**SMALL ARMS RANGE TRAINING AREA
ENVIRONMENTAL SCREENING-LEVEL ASSESSMENT
AT FORT JACKSON, SOUTH CAROLINA**

SUBJECT: Submittal of the Final Small Arms Range Training Area Environmental Screening
Level Assessment at Fort Jackson, South Carolina Report for TRMS 9-CO-160-000-504

**ATC Response to USAEC Comments on
Small Arms Range Training Area Environmental Screening-Level
Assessment At Fort Jackson, South Carolina, May 2004**

Figure 3-5. Proximity of Train Fire Road with Respect to Small arms Range

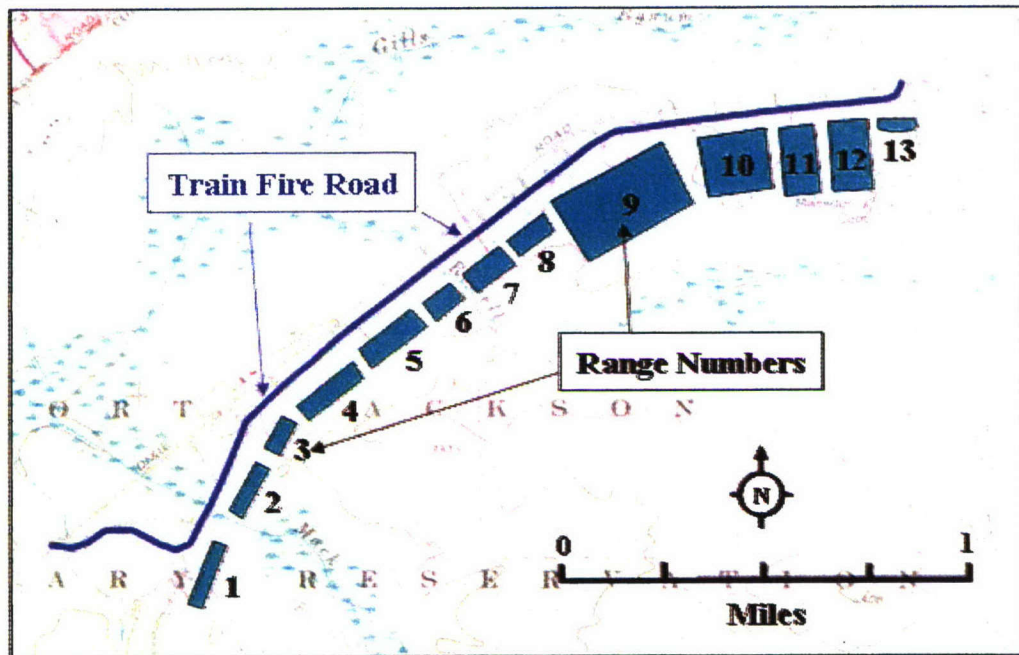
22	Page 17, Figure 3-5	Change "Firetrain Road" to "Train Fire Road" on this figure	Comment incorporated
23	Page 47, Section 6	The current title of this section is "Conclusion for Fort Jackson Small Arms". It should probably be "Conclusions for Fort Jackson Small Arms Ranges"	Comment incorporated
24	Page 55, Figures 7-3 and 7-4.	Both figures for Range 9 require the same corrections done for Figure 3-14 on page 22.	Comment incorporated

Figure 3-15. Range 10 - Qualification Range.

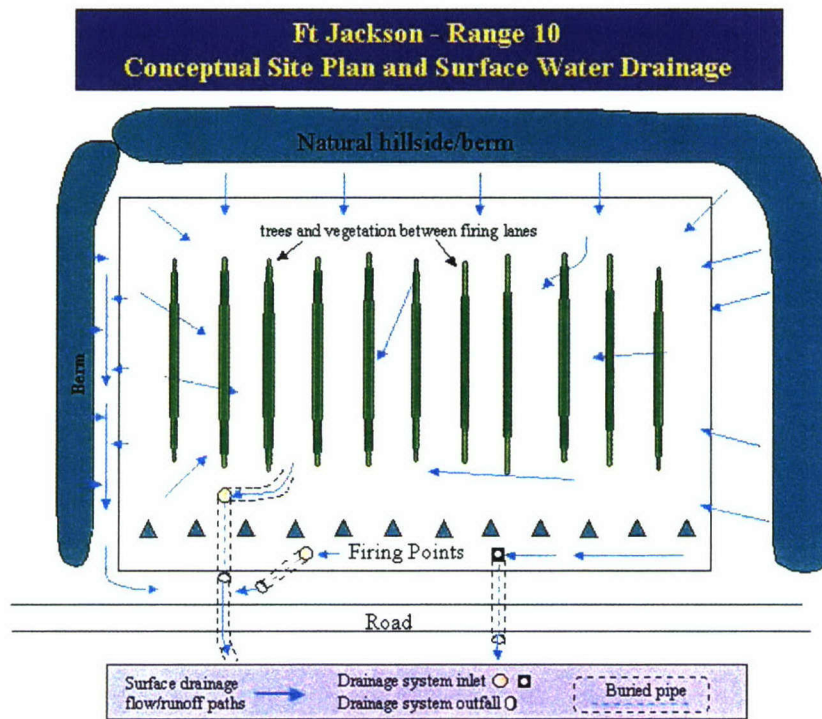
Comment Number	Comment Location	Comment	Response
9	Page 18 1 st full para. Last sentence.	Once again this appears to be an assumption. Reword to say that, "Corrosion is known to occur in environments with..."	The sentence was changed as follows: "An overall estimate of stability as a result of corrosion passivation could not be inferred based on visual observations of the debris. However, corrosion is known to occur in environments with the pH, precipitation, and overall lack of soil nutrient conditions as found at Fort Jackson. These conditions may result in the formation of mobile lead ions."
10	Figures 3-14 and 3-15, page 22.	The depiction of Range 8 on the Range 9 figure does not quite agree with the way it looks on the Range 8 figure. In Figure 3-14, the Range 8 berm extends to the end of the firing lanes, but not to the drainage pipe. In Figure 3-15, it appears to extend past the drainage pipe.	Figure 3-15 has been corrected.
